**MP/LOCAL MEMBER OBJECTION
PETITION**

APPLICATION No. **20/01346/MJR** APPLICATION DATE: 21/07/2020

APPLICANT: TE Cardiff 5 Ltd
LOCATION: 121-123 QUEEN STREET, CITY CENTRE, CARDIFF,
CF10 2BJ

PROPOSAL: CHANGE OF USE OF EXISTING UPPER FLOORS
FROM D1 AND B1 OFFICES TO RESIDENTIAL USE

title
Proposed 1F Plan

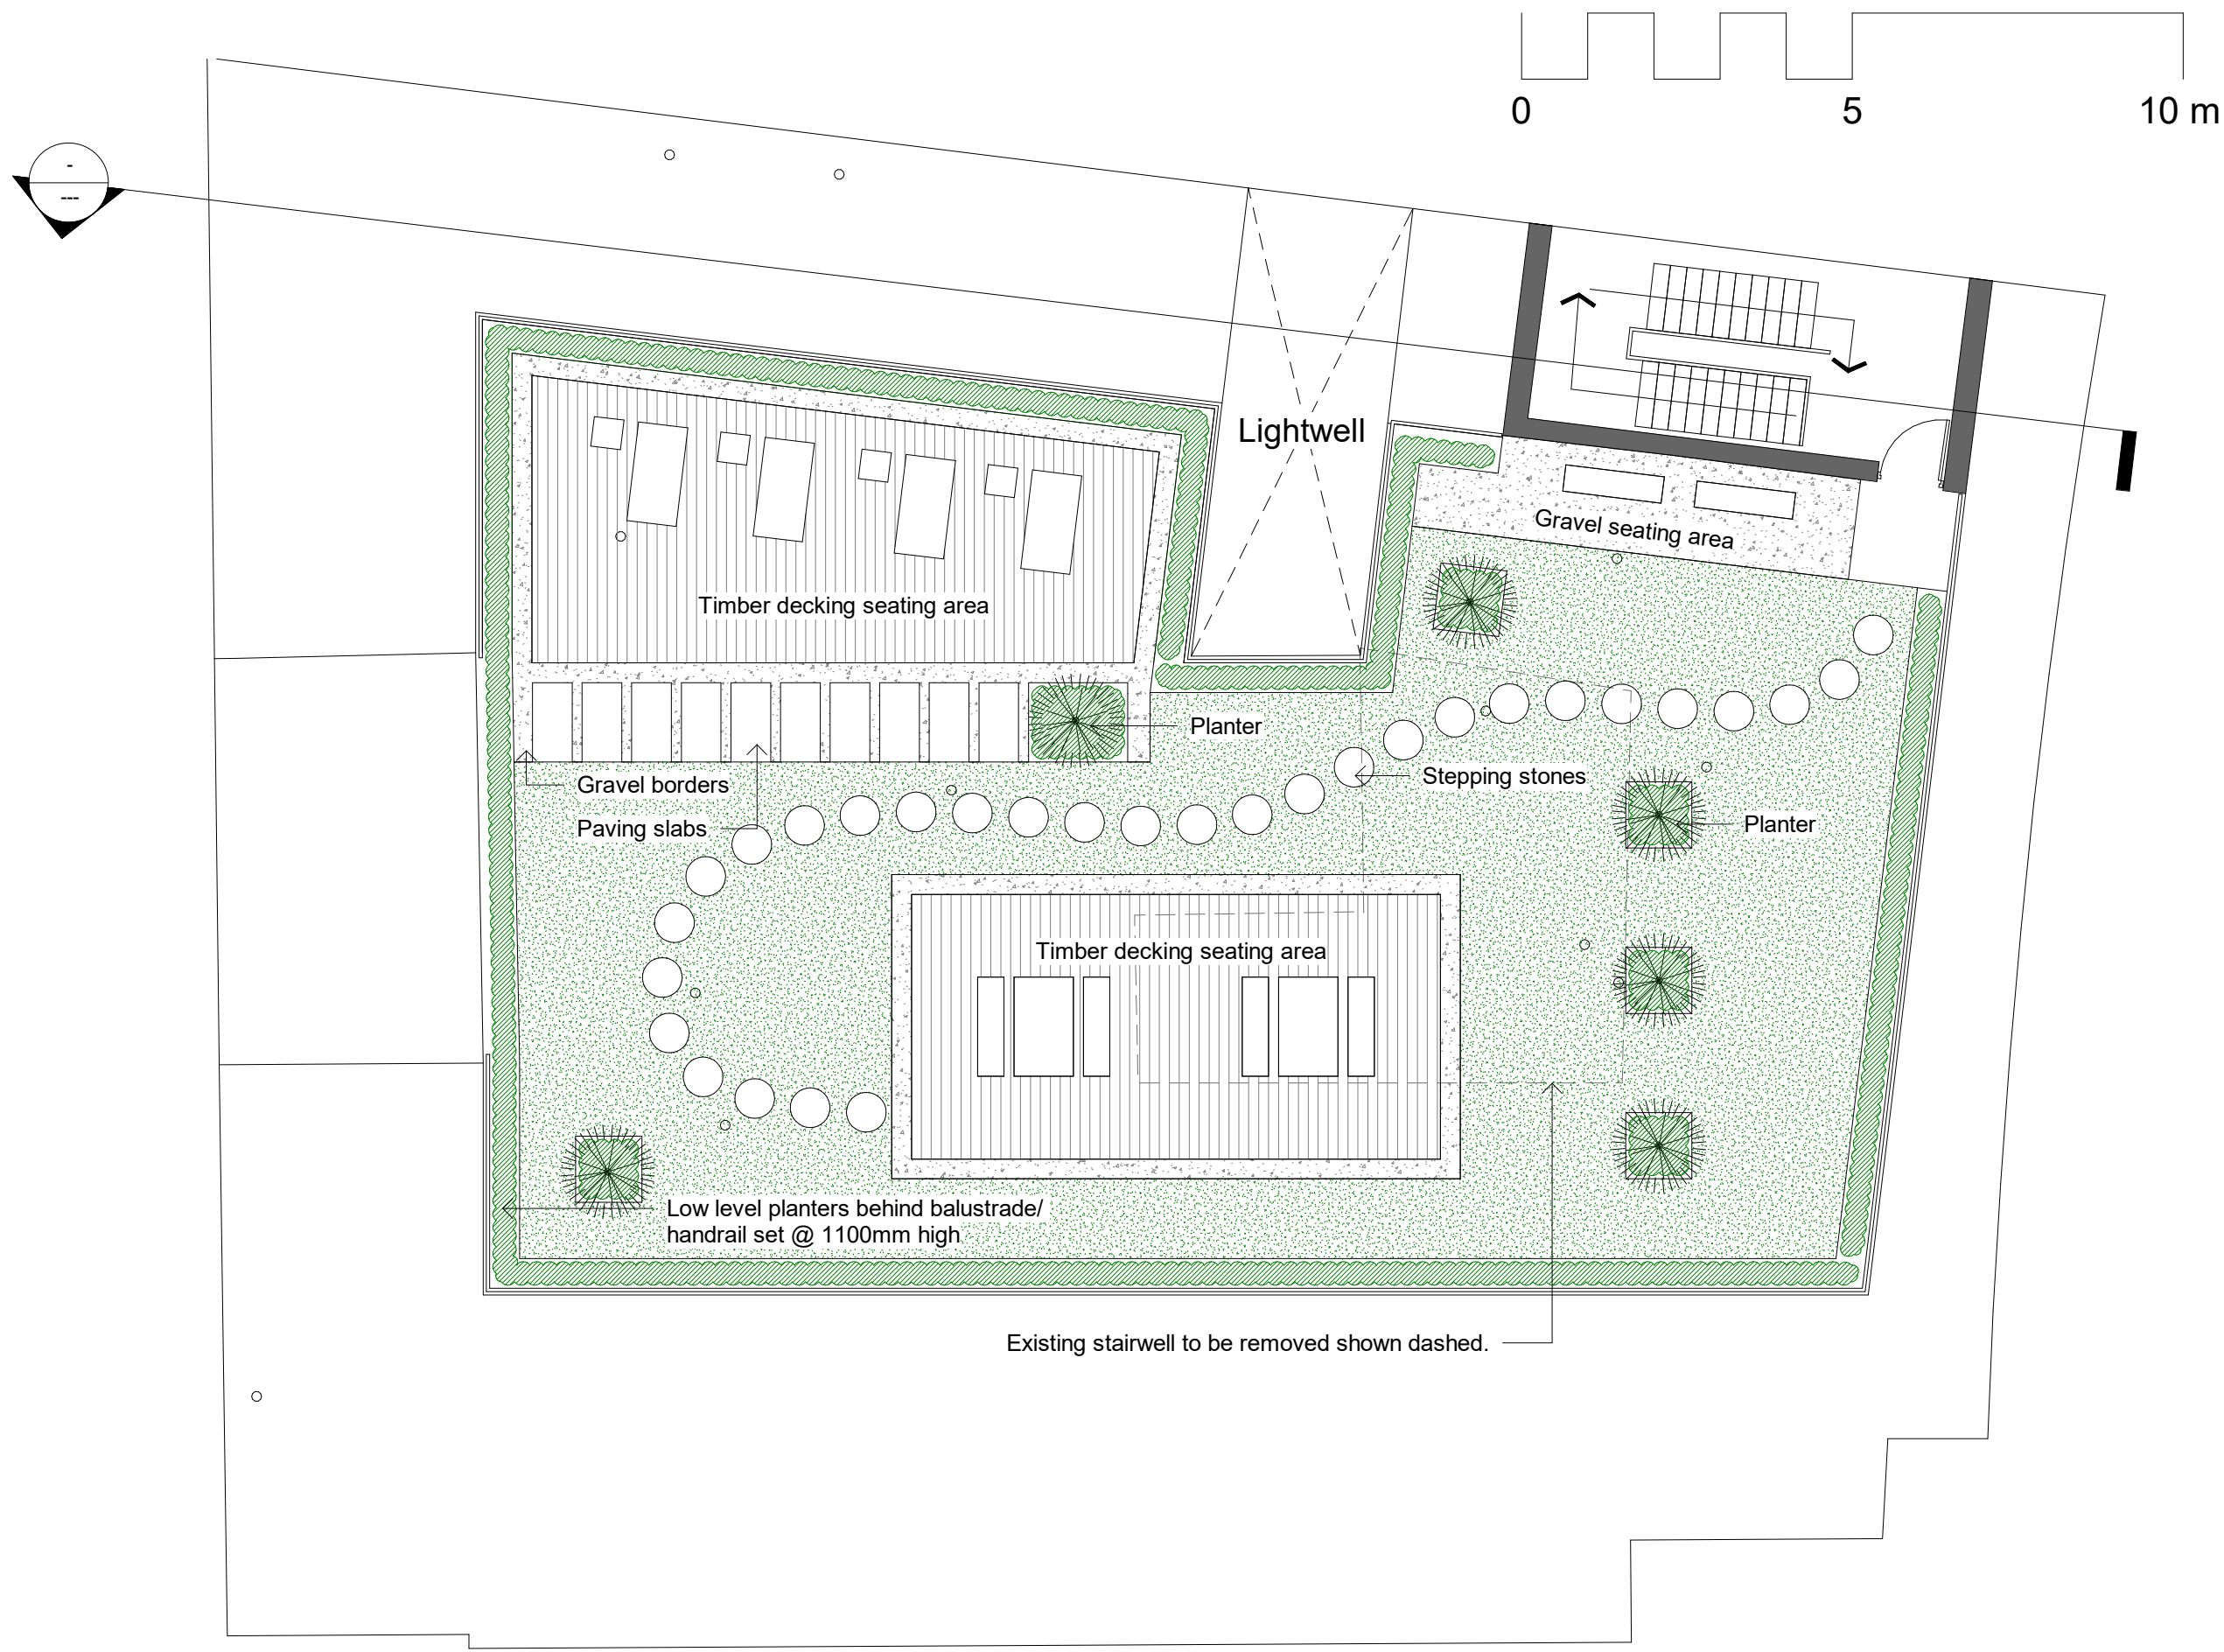
8. The communal hallway and staircase windows that serve the lightwell and overlook the bedroom windows to flats 3, 10 and 17 as identified on the approved plans shall be glazed in obscured glass and shall be non-opening below 1.8m from the finished floor level.

It is also noted that the bedroom windows to flats 3, 10 and 17 have very restricted aspects onto an existing lightwell. Whilst flat 17 (3rd floor) has the best opportunity for light penetration of the three units, it is considered that as these are bedrooms, with all other standards issues considered acceptable, it would be unreasonable to withhold consent on this issue alone.

title
Proposed Roof Plan

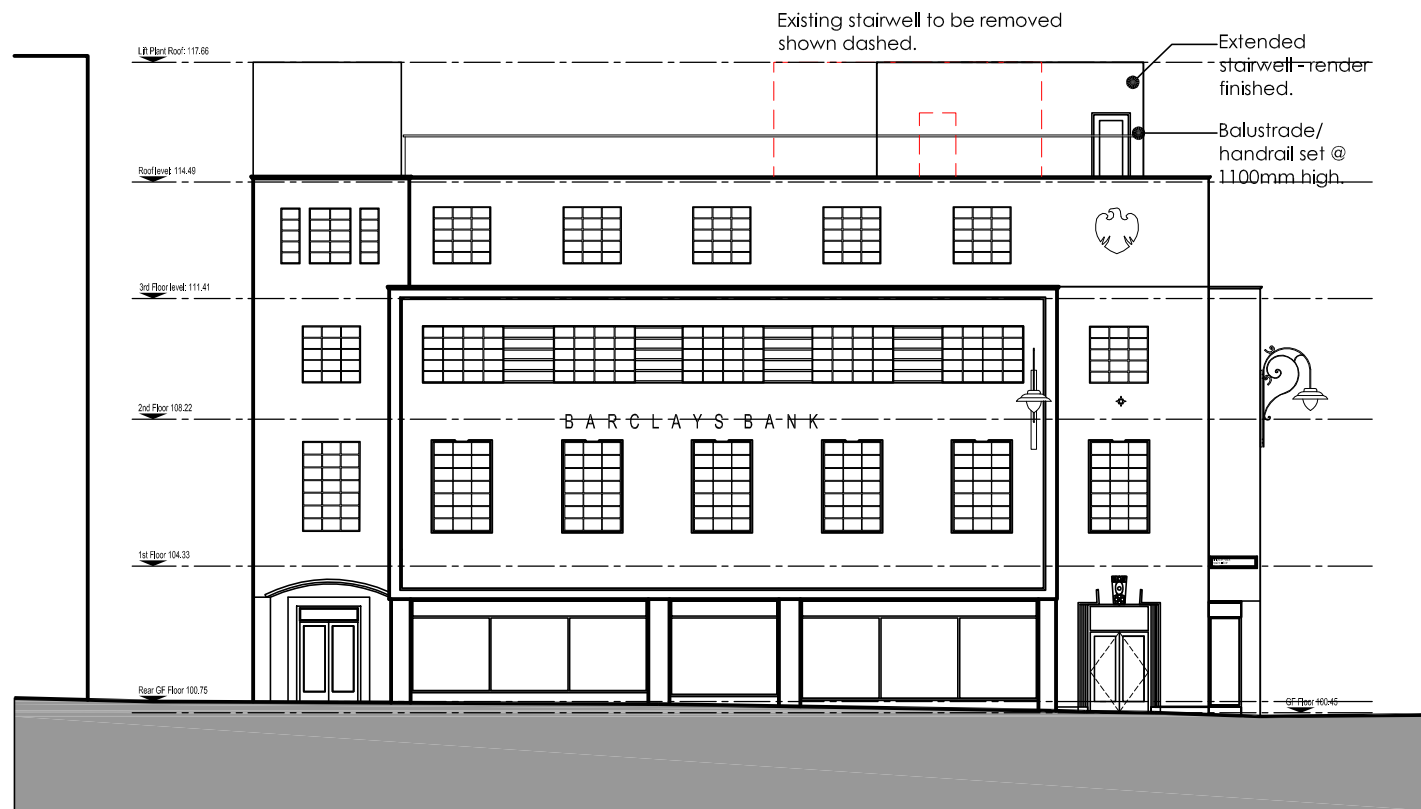
5. Notwithstanding the submitted plans, details of the rooftop amenity space facilities, including (but not limited to) details of rooftop balustrades, potted planting and other materials finishes shall be submitted to and approved in writing by the Local Planning Authority. The approved details shall be implemented prior to the beneficial occupation of the development and shall thereafter be retained and maintained.

- 1.4 There are no external alterations to the building façade proposed, however, the submitted plans indicate a rooftop amenity space, with potted planting and areas for leisure /seating etc, with a new balustrade to be sited inside the existing parapet. This area is accessible to all future residents via the existing lift to the third floor and stairs to the rooftop via a new stairwell access structure beyond.

- 8.7 All future residents would benefit from access to the proposed rooftop terrace via lift to the third floor and then stairs to the roof. Given this potential level of movement past a number of windows that would look into the bedrooms of flats 3, 10 and 17, it is considered reasonable to require the communal area windows affected to be obscurely glazed.
- 8.8 The submitted plans show a rooftop amenity area of approx. 280sqm, benefitting from potted planting, decking and seating areas, with a new balustrade and planter enclosure. This area is set well inside the roof parapet and will not be visible from the street. This area is considered to represent a significant benefit to future residents given the inner city setting of this site and further details of the nature of the planting and finishes are required by condition in order to secure a high quality environment.
